PROPOSED PRODUCT: NBAR (NEW BOLT ACTION RIFLE) - WOOD STOCK VERSION
PRELIMINARY SPEC. (ALSO SEE NBAR STAINLESS SYNTHETIC SPEC.)

GRADE: "A"
ORIGINAL DATE: 8/13/92
REVISED: 8/28/92

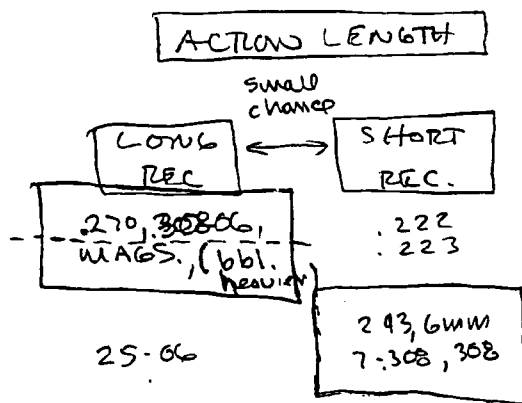
GRADE: "A" ← WHY THIS IF CONCEPT IS UPSIDE HIGH END?

8% OF LONG STOCK BLANKS ARE 7000 "B" GRADE WOOD ACCORDING TO G. HELMER.

BBL LENGTH

LONG BBL
big change
SHORT BBL

LONG F.E.

SHORT F.E.

5 ~~4~~ STOCK VARIATIONS TAILORED TO:

- BARREL LENGTH (COSMETIC-PROJECTION)
- ACTION LENGTH (INLETTING)
- BBL COUNTOUR (+3/4 LB IN WAGS)

⇒ PUT 25-06 IN WITH
"LONG BBL HUN" CALIBERS

GO FROM 4 TO 2

COMBINE BBL COUNTOUR
ON LONG ACTION TO
SEMI-MAGNUM.

ASSUME:
F.E. LENGTH
VARIES WITH BBL
LENGTH TO PROVIDE
AESTHETIC APPEAR.
